Maxtor Corporation
500 McCarthy Boulevard
Milpitas, CA 95035 USA

To: T10 CAP Working Group
Contact: Mark Evans
Phone: 408-894-5310
Email: mark_evans@maxtor.com
Date: 07 May 2003

Subject: SAM-3, SPC-3, and SBC-2 power conditions proposal

Figure a — Power condition state machine

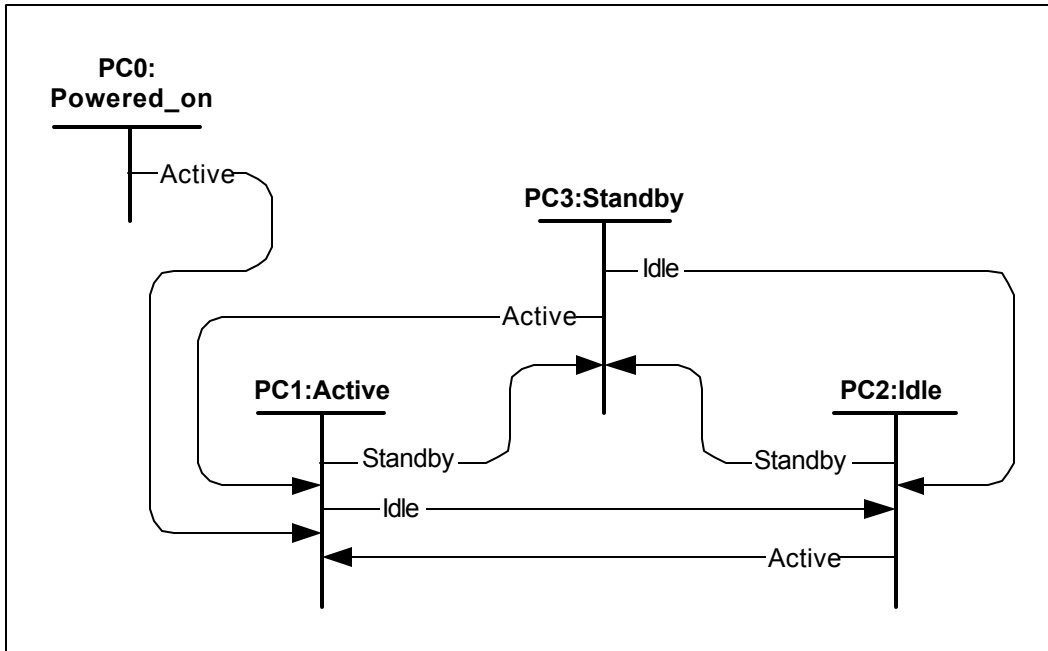
In SPC-3: Replace subclause 5.8 with the following:

Figure a describes the PC state machine.

The PC (power condition) state machine describes the logical unit power states and transitions resulting from Power Condition mode page settings.

- a) PC0:Powered_on (see 5.8.2.2) (initial state);
- b) PC1:Active (see 5.8.2.3);
- c) PC2:Idle (see 5.8.2.4); and
- d) PC3:Standby (see 5.8.2.5).

The PC state machine stall start in the PC0:Powered_on state after power on.

Figure b — Power condition state machine for logical units implementing the START STOP UNIT command

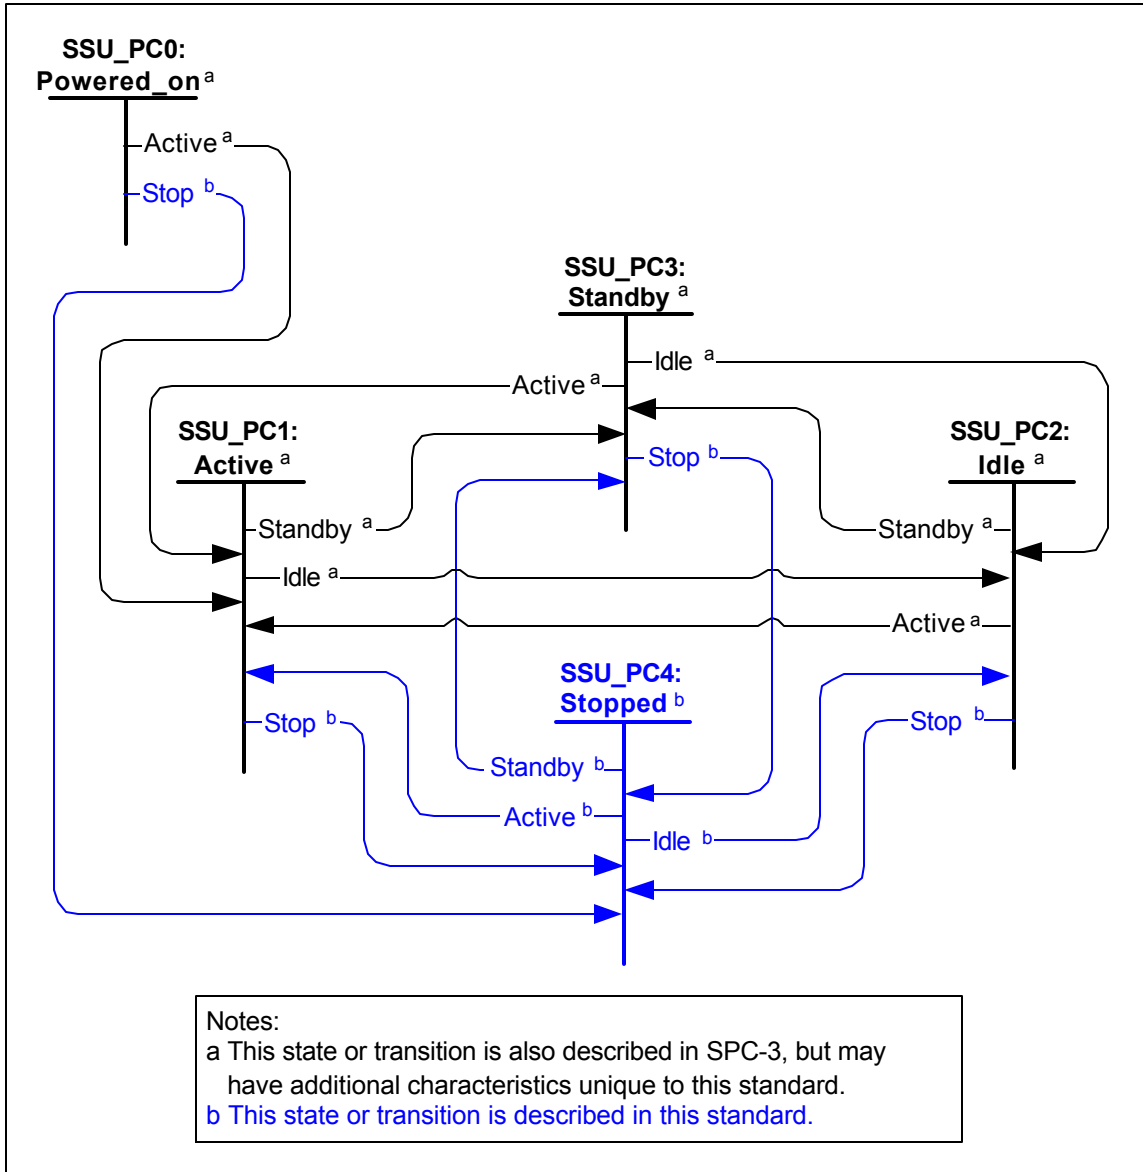
In **SBC-2**: Add the following in the Models clause.

Figure b describes the SSU_PC state machine.

The SSU_PC (start stop unit power condition) state machine for logical units implementing the START STOP UNIT command describes the logical unit power states and transitions resulting from settings by the START STOP UNIT command and settings in the Power Condition mode page (see SPC-3).

- a) SSU_PC0:Powered_on (see 4.2.1.0.2.2) (initial state);
- b) SSU_PC1:Active (see 4.2.1.0.2.3);
- c) SSU_PC2:Idle(see 4.2.1.0.2.4);
- d) SSU_PC3:Standby (see 4.2.1.0.2.5); and
- e) SSU_PC4:Stopped (see 4.2.1.0.2.6).

The SSU_PC state machine shall start in the SSU_PC0:Powered_on state after power on.
